### **Request for Class II Permissive Change**

FCC ID: ZVABDDMPBD87 Date: 2012- 2 - 16

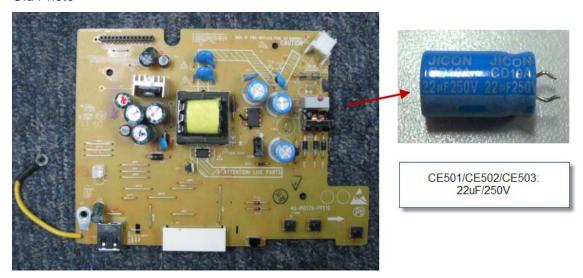
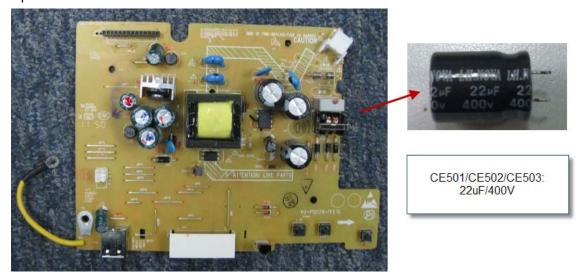
Change the input rating from 120V 60Hz to be 110-240V 50/60Hz.

Item	old	updated	Remark
1	Input: 120V 60HZ	Input: 110-240V 50/60Hz	
	15W	15W	
2	Value of below capacitance:	Value of below capacitance:	
	CE501 、 CE502 、 CE503 : 22uf/250V	CE501、CE502、CE503: 22uf/400V
